City of Lakewood
Board of Zoning Appeals

MINUTES
BOARD OF ZONING APPEALS
REVIEW MEETING
LAKEWOOD CITY HALL
JULY 17, 2025
6:30 P.M.
RECORDING AVAILABLE
<https://www.lakewoodoh.gov/videos-2/>

4. Docket No. 07-11-25 1649 Belle Ave.

5. Docket No. 07-12-25 12984 Lake Ave.

Proposed View - Looking NW

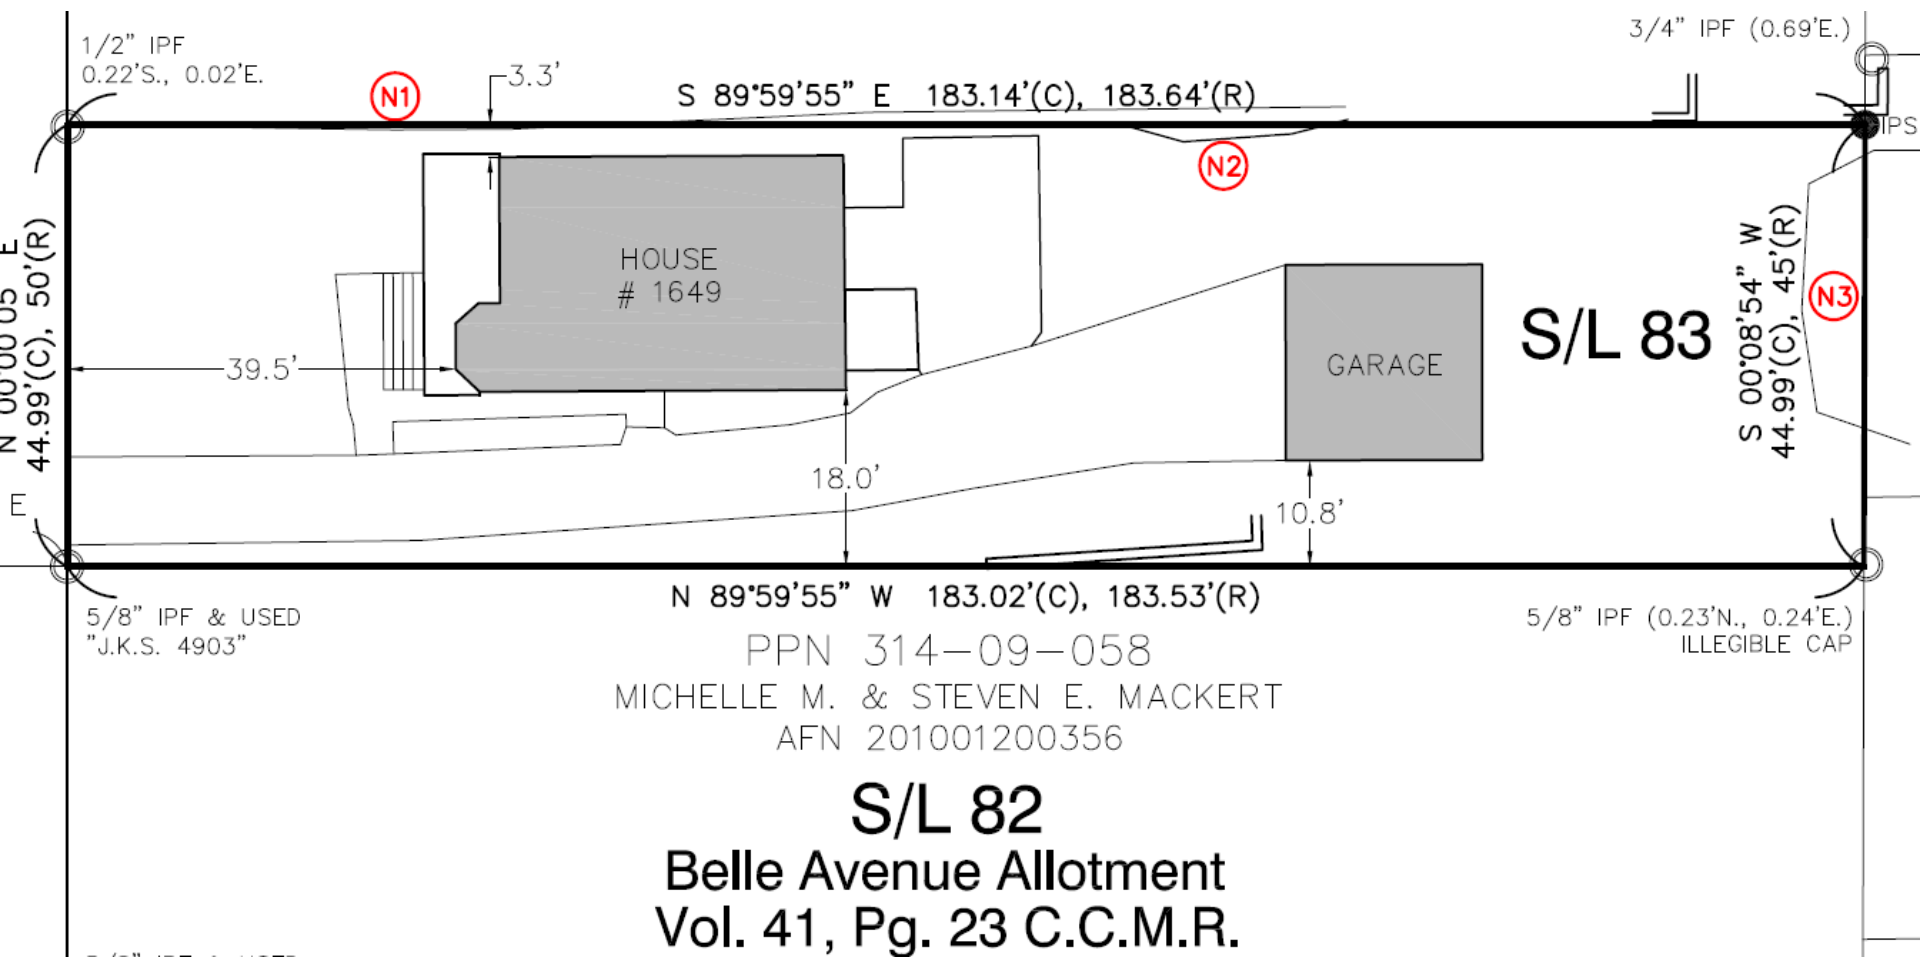
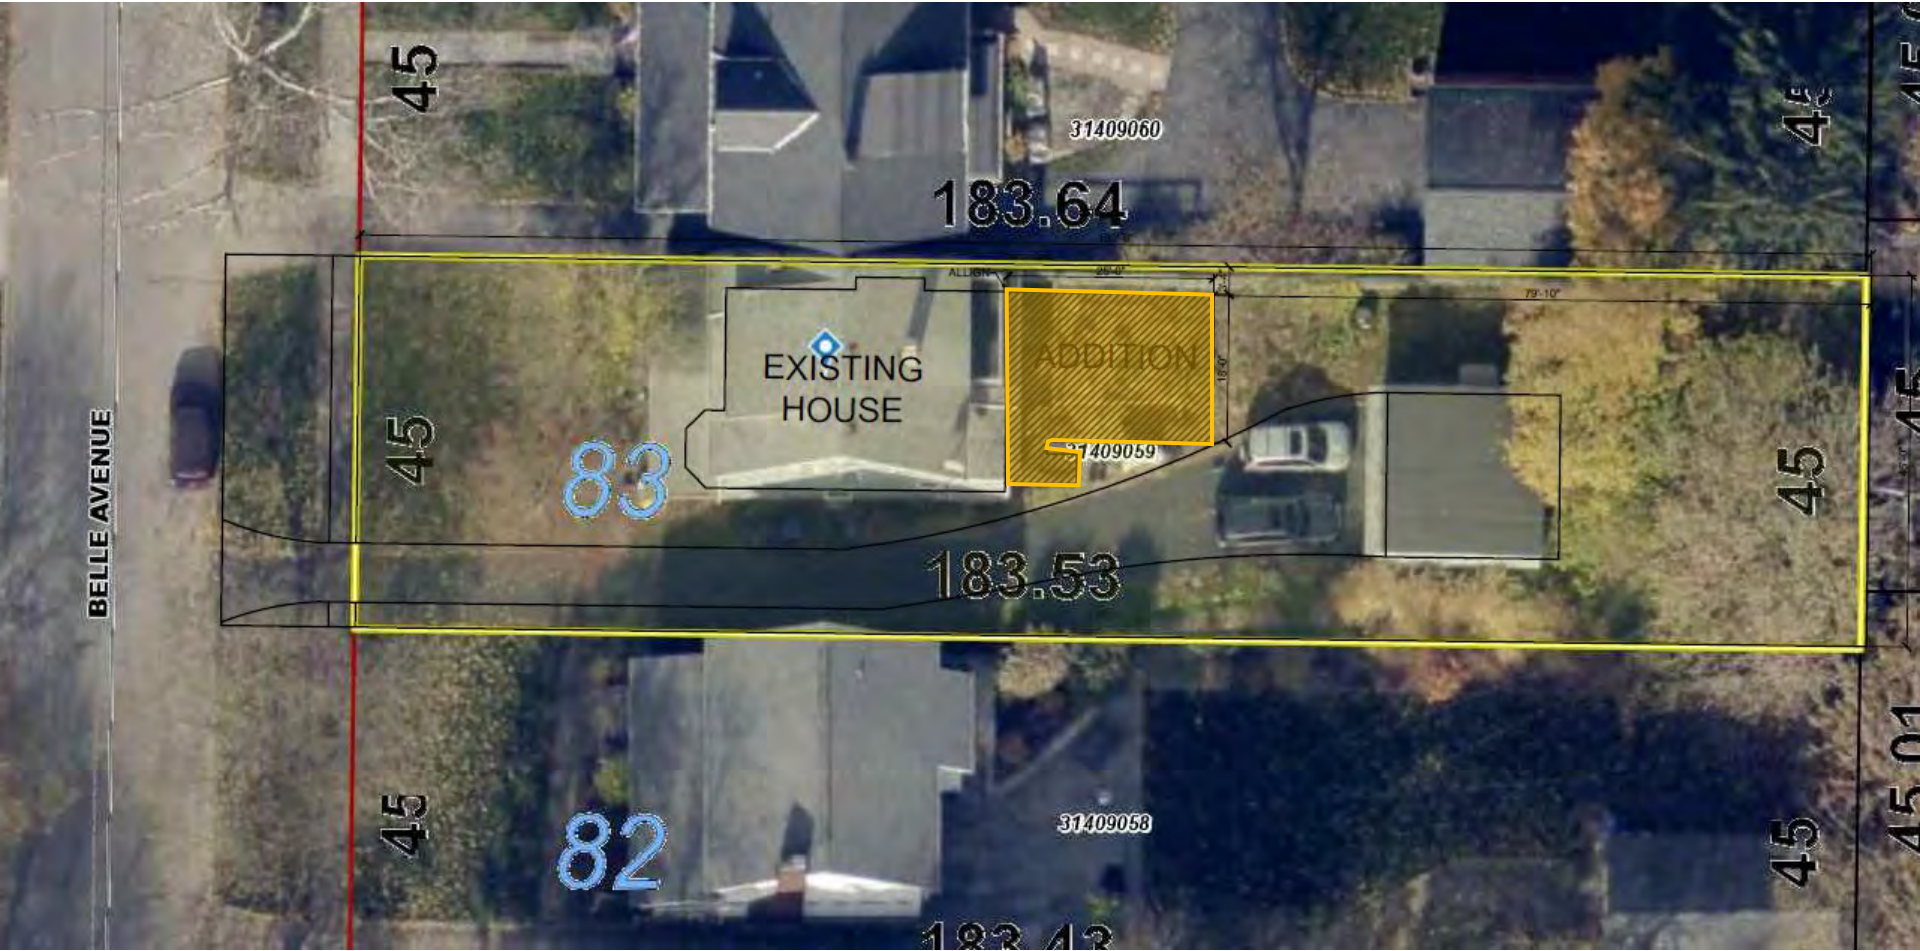
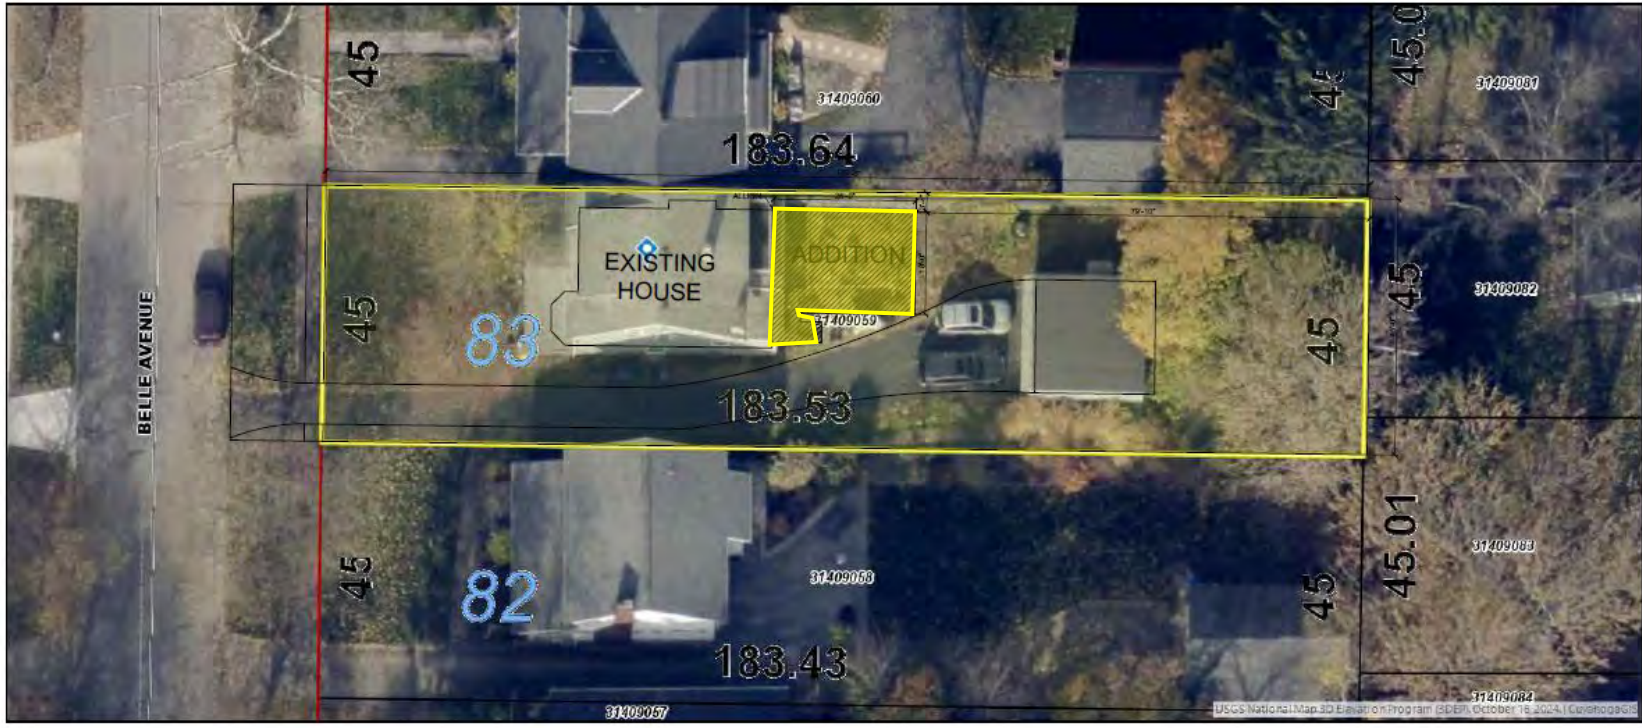
- The board has approved a number of these small elevated unroofed patio decks each year with no negative consequences either observed or reported.
- The deck size is 170 sq feet, a modest size
- There is an existing second story unroofed patio deck of approx. 80 square feet that is being removed and replaced by this larger addition with the new deck in a different location on the rear of the structure
- The air conditioner must either be no closer to the side property line than the existing setback or meet the requirements for decibel ratings and placement for an ac in a side yard.

A motion was made by Mr. Santiago, seconded by Mr. Markling to APPROVE the request for one variance as proposed. Ms. Bolino, Mr. Markling, Mr. Pigott, and Mr. Santiago voted yea, the motion passed.

Estate Residential Gate , 22' W X 5' to 6' H , Black, Longspur-
With Open Top Puppy Picket- set Double as a Double Gate .

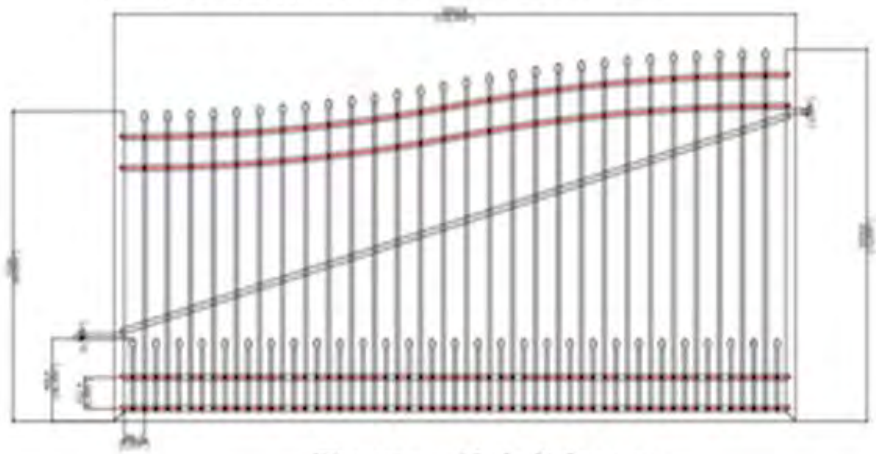
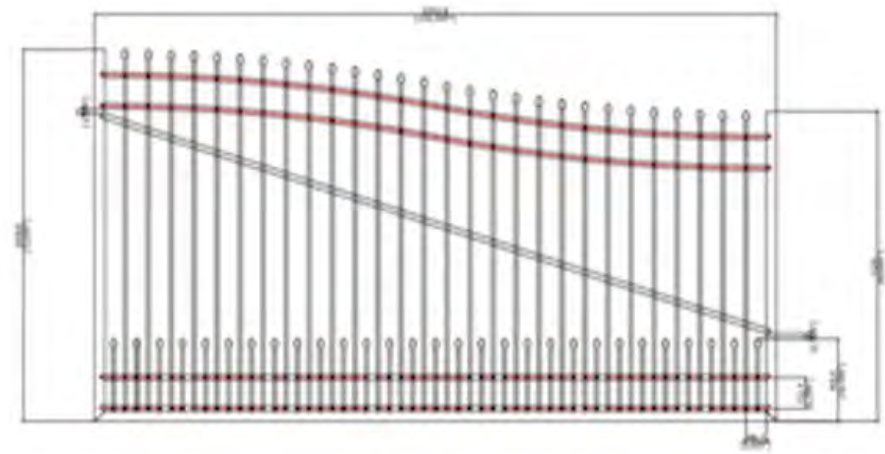
- New front yard gates and walls are not permitted under current code, however, there are several large historic properties on Lake Ave that have existing historic walls and gates, or a historic wall and a gate that has been added more recently through a variance. This property has been designated a historic property, and the gate has been approved by the ABR through a certificate of appropriateness. The gate will be adjacent to the historic wall, not attached to it.

- The city sold this property to the current owners to live in and rehabilitate in November of 2024, the city retains the adjacent lot 12980 Lake Ave. that was created by splitting the original lot. Access to the city's parcel at 12980 Lake will eventually be through a new opening in the wall that the city will create, and the city will request a variance to install a gate for the security of the sewer infrastructure facilities that will be installed at 12980 Lake Ave.

- The purchase agreement includes an easement that insures access to 12980 Lake by the city. The administration does not object to this request as the city's continued access to 12980 Lake is established through the easement and shall not be infringed by the variance.

A motion was made by Mr. Santiago, seconded by Ms. Bolino to APPROVE Docket No. 07-12-25 for one variance as proposed. Ms. Bolino, Mr. Markling, Mr. Pigott, and Mr. Santiago voted yea, the motion passed.
